TECHNICAL SERVICE BULLETIN

Timberline - Differential Fluid Venting From The Rear Axle

22-2406

Ford 2021-2023 Explorer	Timberline
-----------------------------------	------------

Figure 1

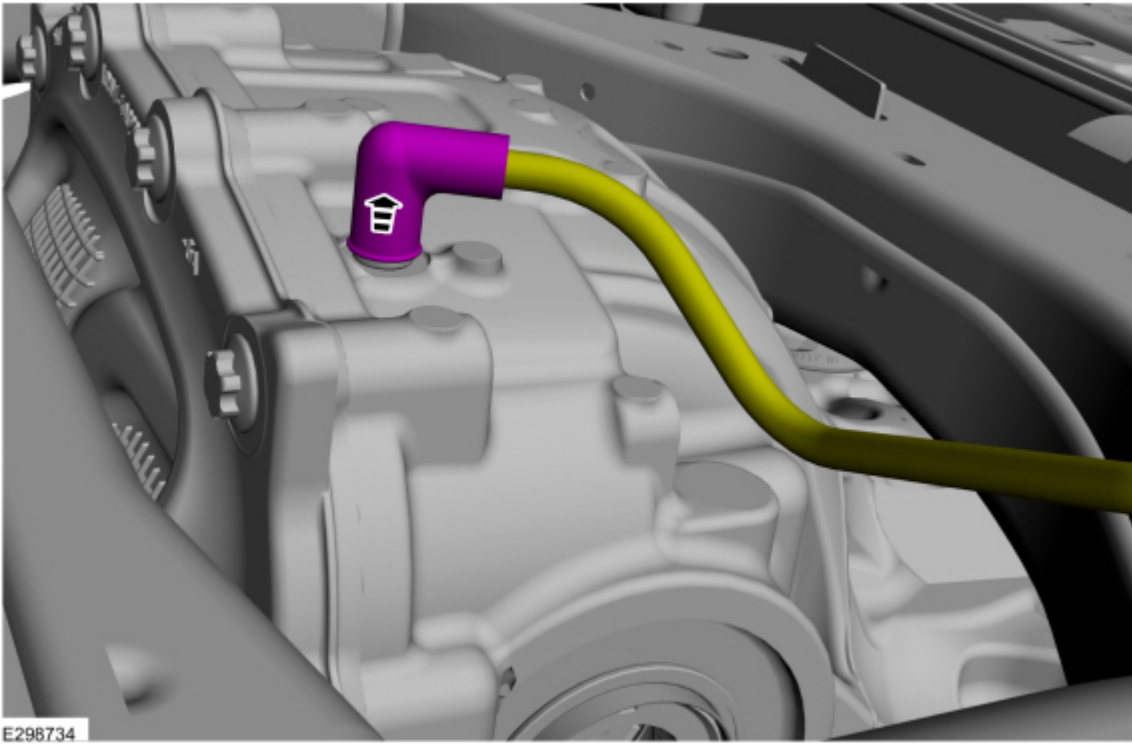
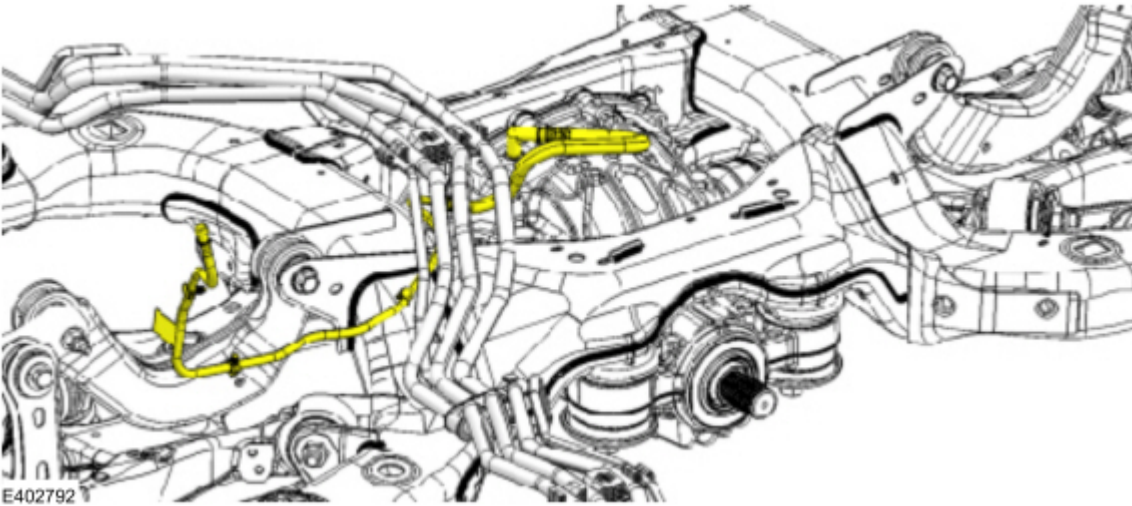
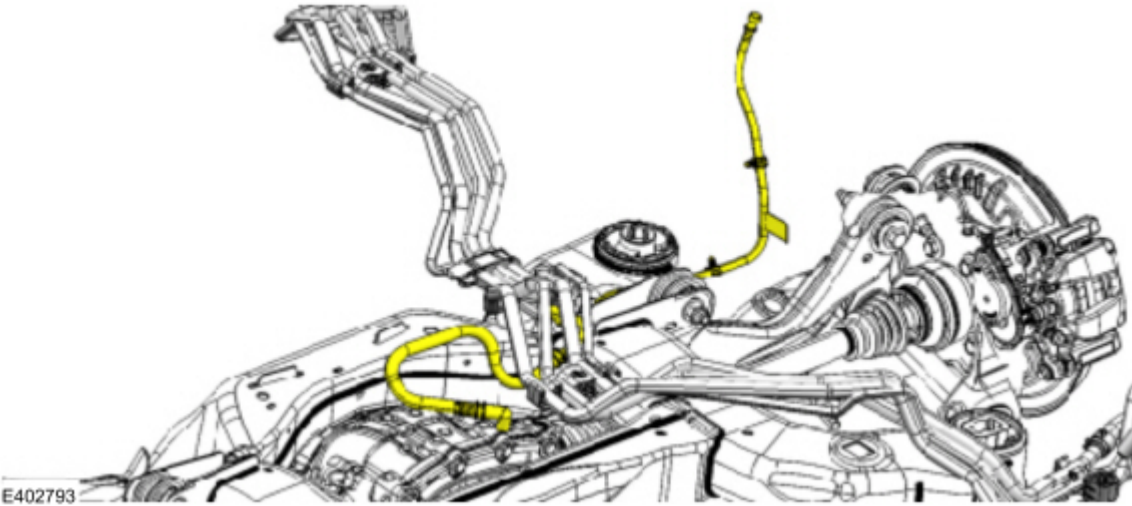
Issue: Some 2021-2023 Explorer Timberline vehicles may exhibit differential fluid venting from the differential fluid vent. The customer may notice differential fluid pooling below the vehicle, or saturating the wheel well liner. This may be due to the differential vent tube not having enough positive incline. To correct the condition, follow the Service Procedure to replace the differential vent tube.

1. Remove and discard the differential vent tube. Refer to Workshop Manual (WSM), Section 205-02.
2. Install the new differential vent tube. Make sure that the vent tube is routed correctly and maintains a positive slope on the curvature near the differential. (Figures 1-3)

NOTE: It may be beneficial to use a borescope to view the differential vent tube mounting and make sure the vent tube is fully seated and is sloping upward.
